## **MARITECH MARINE SUBDIVISION, PHASE 2**

Engineering Comments: The following comments should be addressed prior to submitting the FINAL PLAT for acceptance and signature by the City Engineer:

APPLICATION NUMBER 5 DATE May 21, 2015

# DETAIL SITE PLAN

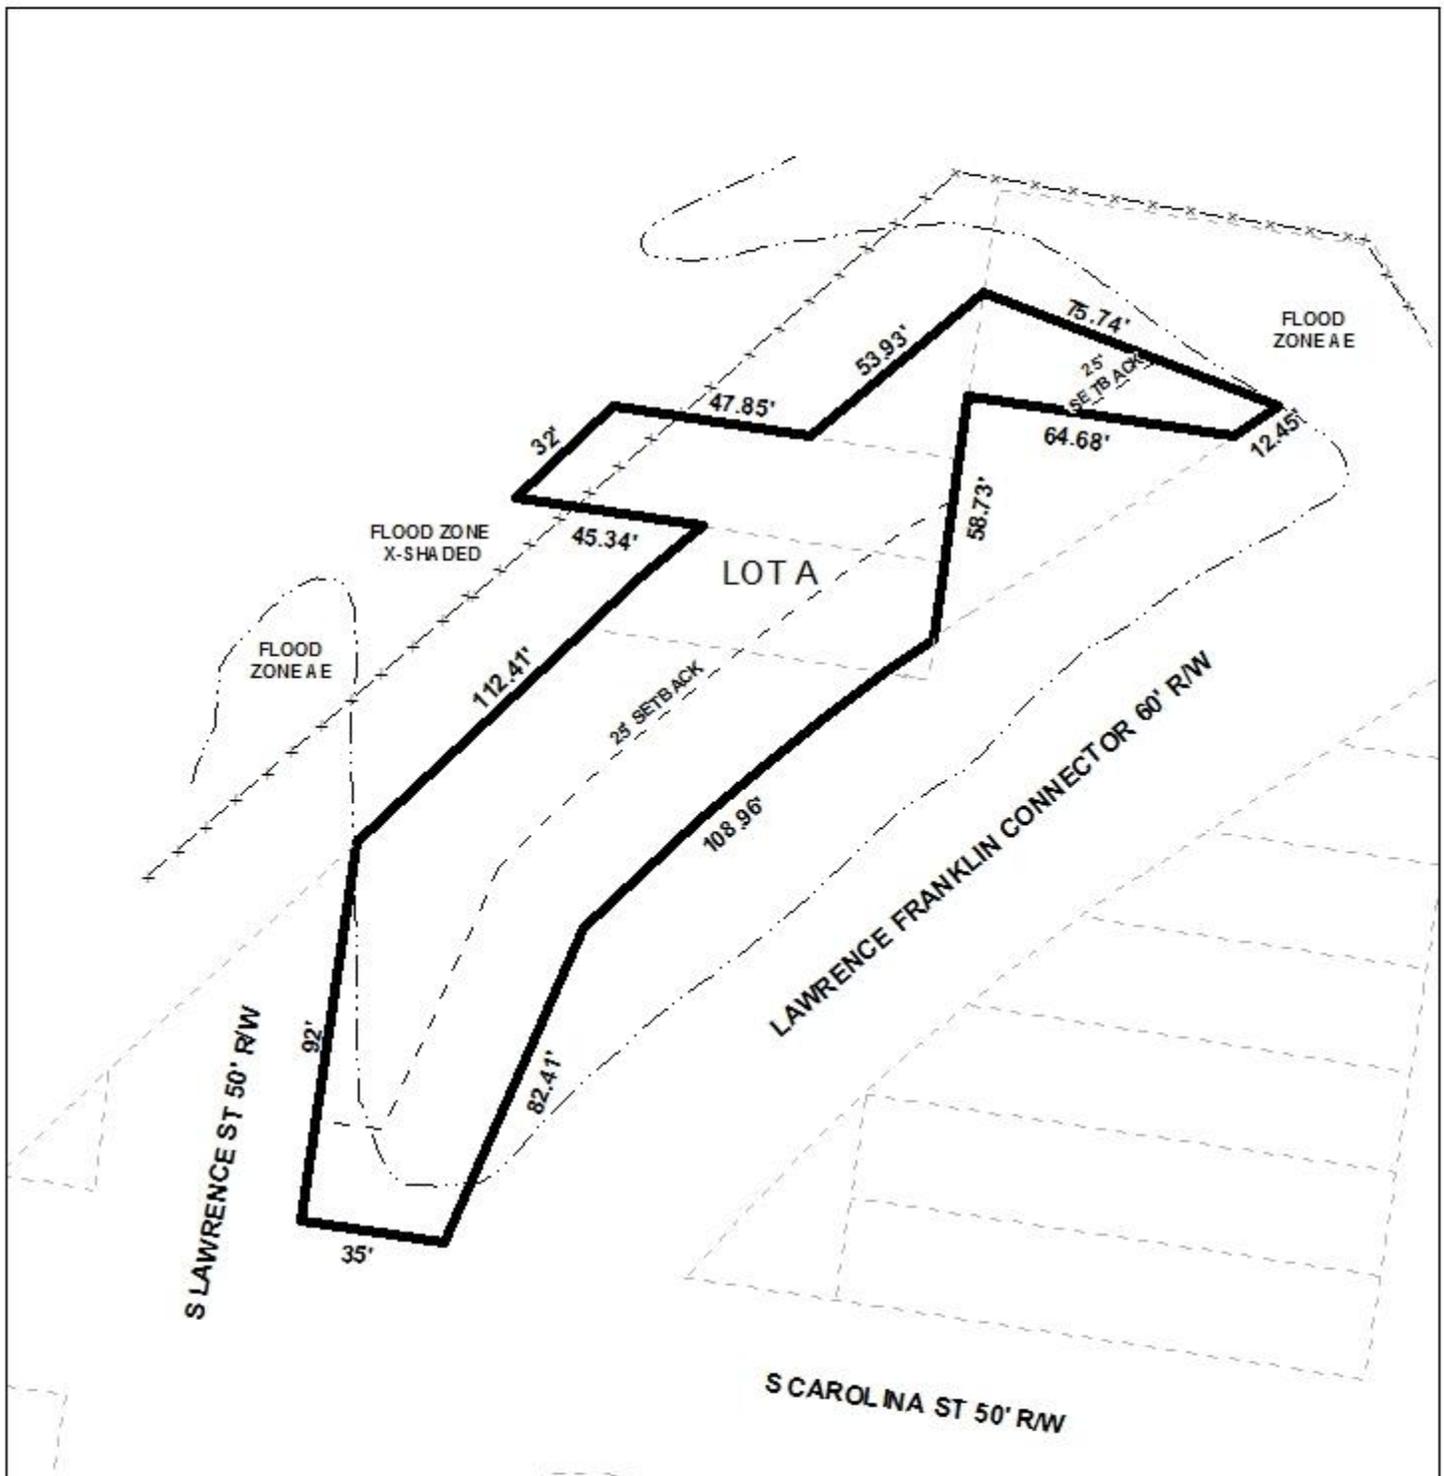
- A. Delete the reference to the POB located at the southwest corner of LOT 1, Maritech Marine Subdivision, unless needed.
- B. Add a note to the SUBDIVISION PLAT stating that a Land Disturbance permit will be required for any land disturbing activity in accordance with Mobile City Code, Chapter 17, Storm Water Management and Flood Control); the City of Mobile, Alabama Flood Plain Management Plan (1984); and, the Rules For Erosion and Sedimentation Control and Storm Water Runoff Control.

- C. Add a note to the Plat stating that the approval of all applicable federal, state, and local agencies (including all storm water runoff, wetland and floodplain requirements) will be required prior to the issuance of a Land Disturbance permit.

- D. Provide the Surveyor's, Owner's (notarized), Planning Commission, and Traffic Engineering signatures.
- E. Add a note that sidewalk is required to be constructed, and/or repaired, along the frontage of each lot, or parcel, at time of development, unless a sidewalk waiver is approved.

The proposed lot is located on a curve, and access management is a concern due to the site abutting Interstate 10. The lot should be denied access to Interstate 10, the remnant South Lawrence and South Carolina Streets, and limited to one curb-cut to the Lawrence Franklin Connector with the size, design and location of the curb-cut to be approved by Traffic Engineering and conform to AASHTO standards.

The 25' minimum building setback line, required in Section V.D.9. of the Subdivision Regulations is shown for the lot where it abuts the Lawrence Franklin Connector and South Carolina Street, but not where the lot abuts the remnant South Lawrence Street and Interstate 10. The applicant indicates a zero setback along the Interstate 10 right-of-way as on the previous approval. This was requested along the remnant South Lawrence Street and Interstate 10 due to the fact that providing a 25-foot setback from these two streets would essentially result in an unbuildable lot. Staff recommended that the normal 25' setback be waived and the previous Subdivision was allowed such. Therefore, staff recommends that the 25' setback along the Interstate 10 right-of-way be waived for the expanded portion as well.

As on the preliminary plat, the lot should be labeled with its size in both square feet and acres on the Final Plat, or a table should be furnished on the Final Plat providing the same information.
